Technical Service Bulletin

37 Transmission malfunction, DTC P17F600, P17F500, P17F400, U008000, and/or U010100 stored in the TCM or ECM

37 19 91 2053878/7 November 21, 2019. Supersedes Technical Service Bulletin Group 37 number 19-90 dated November 8, 2019 for reasons listed below.

Model(s)	Year	VIN Range	Vehicle-Specific Equipment
A6, A7	2019	All	3.0TFSI

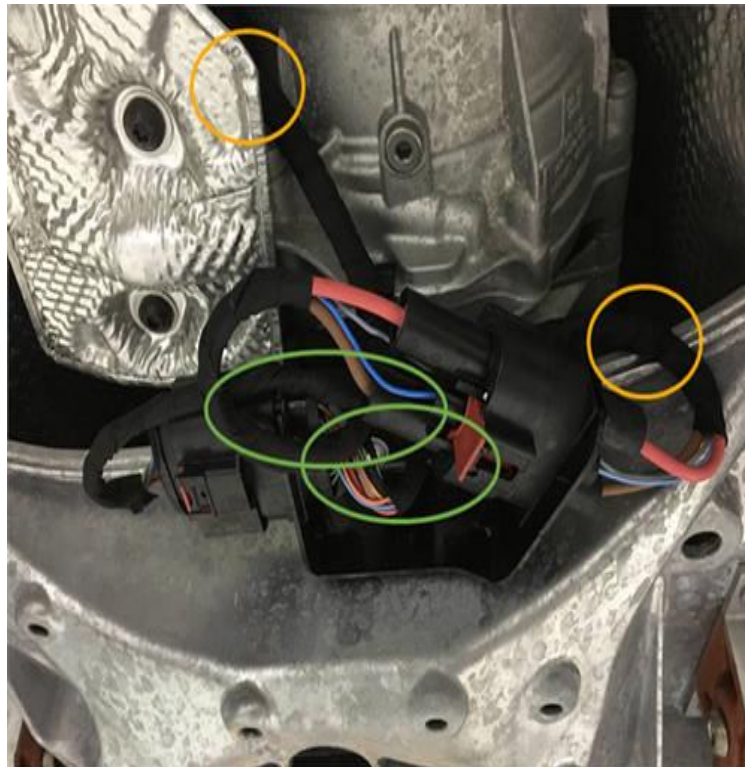
The transmission harness can come in contact with the transmission crossmember and could be damaged.

The body harness containing the FlexRay circuit to the transmission may rub against the mounting bracket of the driver assist systems control module, J1121 (address word 00A5).

Optimized transmission wiring harness and routing implemented in production.

Figure 7. New routing and wrapping of the aft part of the transmission harness.

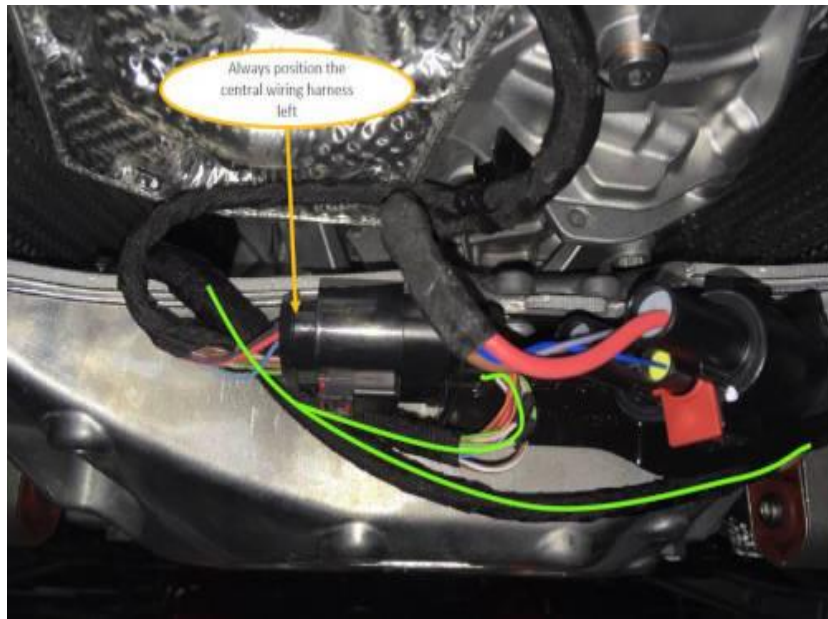
3. Replace the original transmission harness with a new part and reroute the transmission harness. The transmission harness should not be repaired.
 - Remove the original transmission harness in the vehicle.
 - Wrap the exposed wires on the new transmission harness as shown in Figure 7.
 - Mount and route the new transmission harness as shown in Figure 8.
